ROADWAY PLAN

Kaneohe Bay Drive Improvements

Federal Aid Project No. STP-065-1(9)

2/3/03 Revised Driveway Per Addendum No. 1

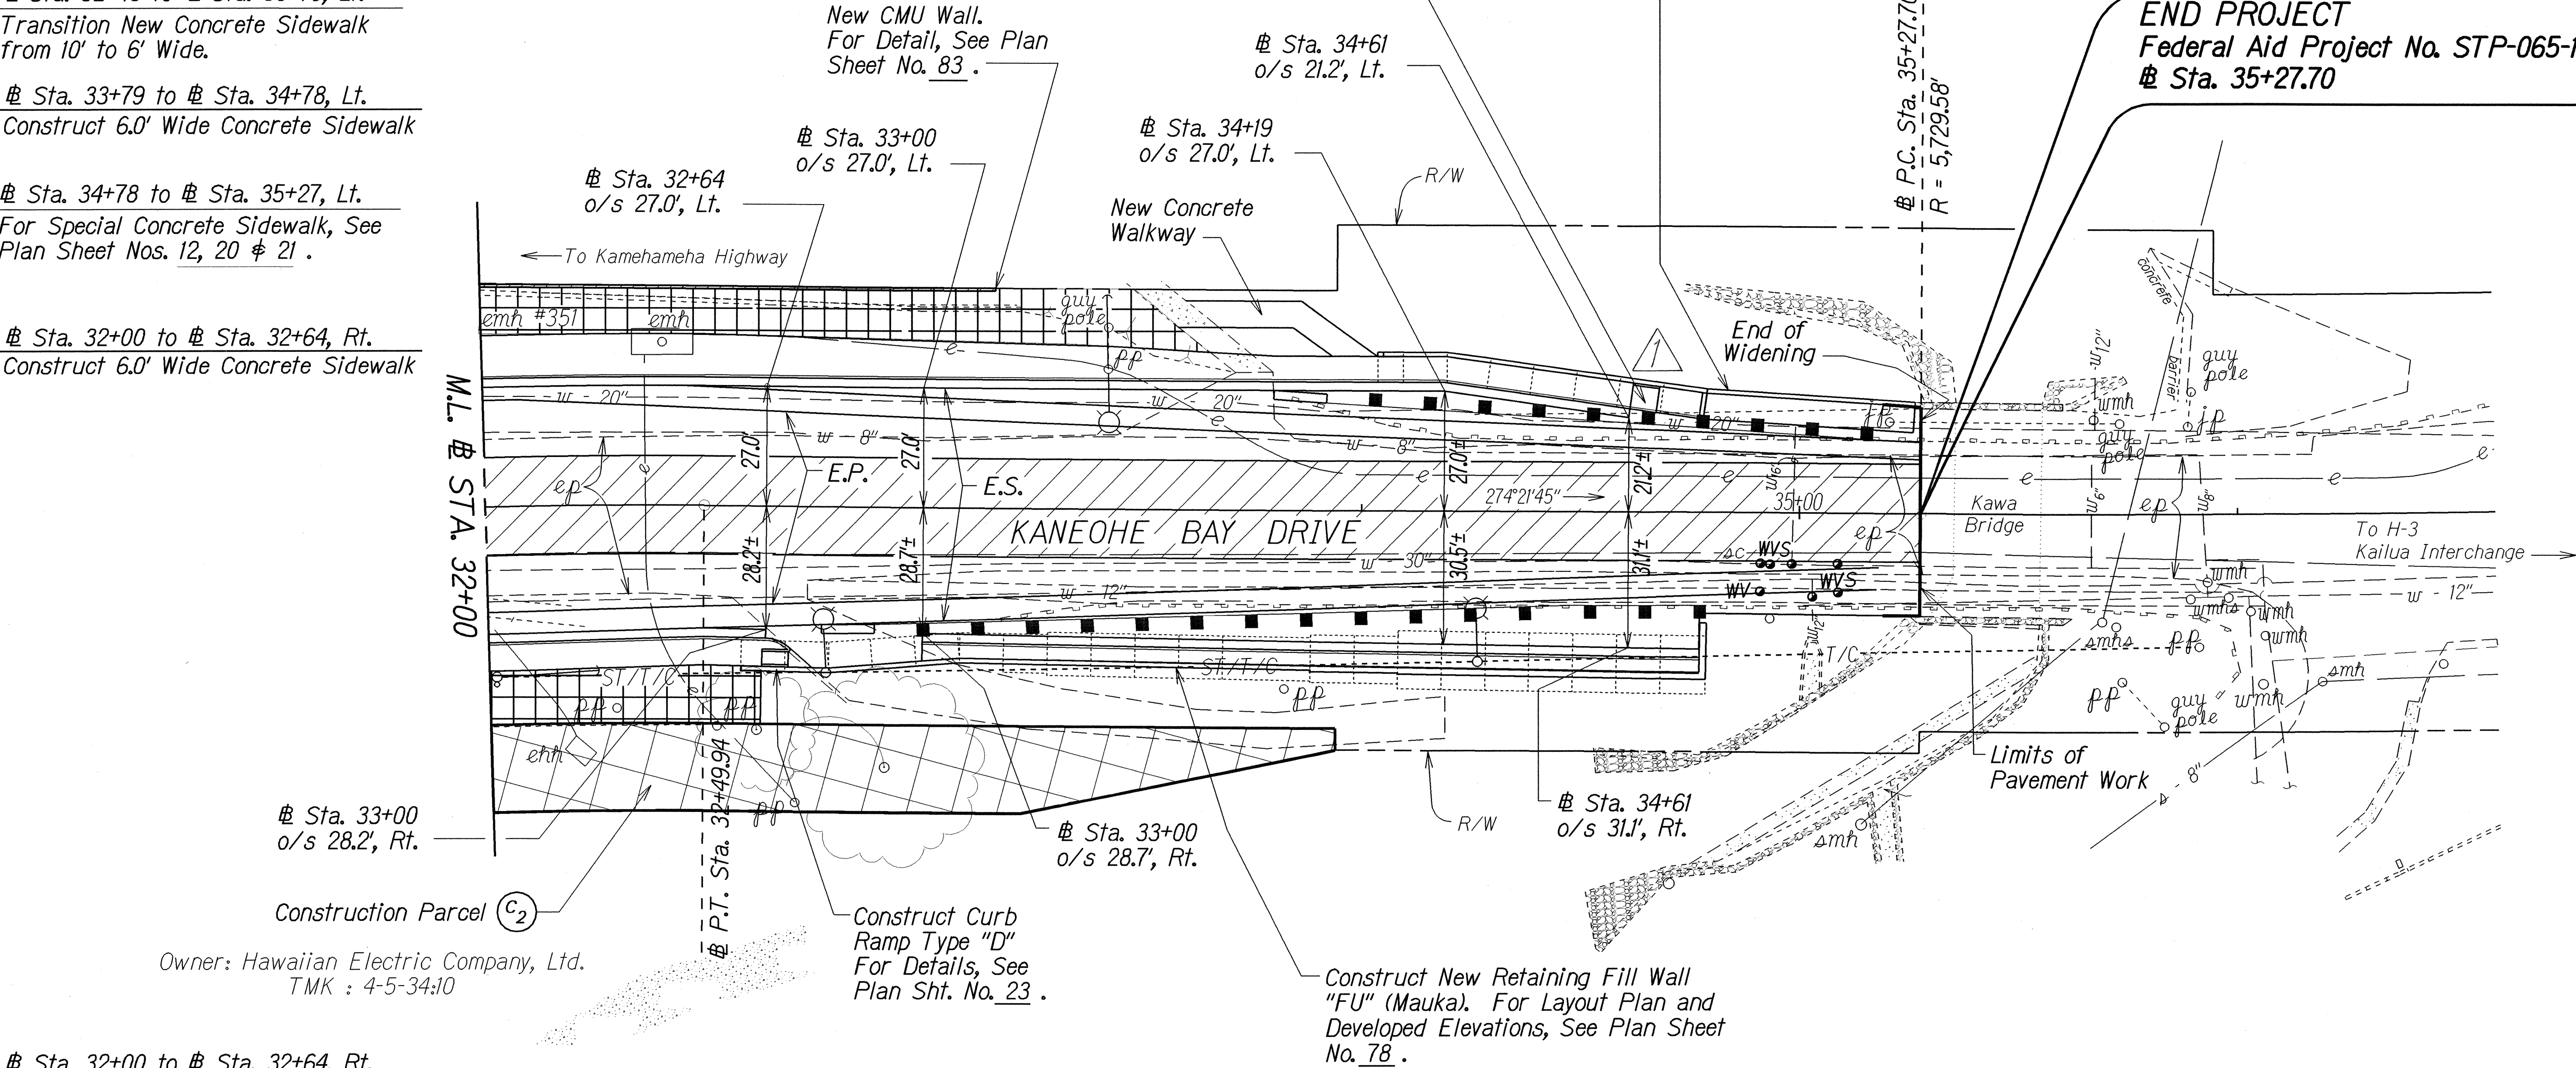
1	2/3/03	Revised Plan to Show New Work At Sta. 34+65± Left
	DATE	REVISION
STATE OF HAWAII DEPARTMENT OF TRANSPORTATION HIGHWAYS DIVISION ROADWAY PLAN KANEOHE BAY DRIVE IMPROVEMENTS Vicinity of Puohala Street to Kawa Bridge Federal Aid Project No. STP-065-1(9) Scale: 1" = 20' Date: June, 2002 SHEET No. 4 OF 4 SHEETS

Sta. 33+82 to Sta. 35+27, Lt.
Remove 146 L.F. of Existing Guardrail and Terminal Section and Install 136 L.F. of New Guardrail Type 3 Single w/ Steel Posts and provide new NCHRP 350 Terminal Impact Attenuator. See Note. Connect New Guardrail to Existing Guardrail.

NOTE:
NCHRP 350 Crash Cushions shall be for System width = 30", shall consist of 3 bays minimum, shall be Redirective, Non-Gating and approved by FHWA and HDOT for 45 mph velocity. Furnish and Install Quadguard System or TAU-II; Terminal Impact Attenuator. Refer to Special Provisions Specification Section 693.
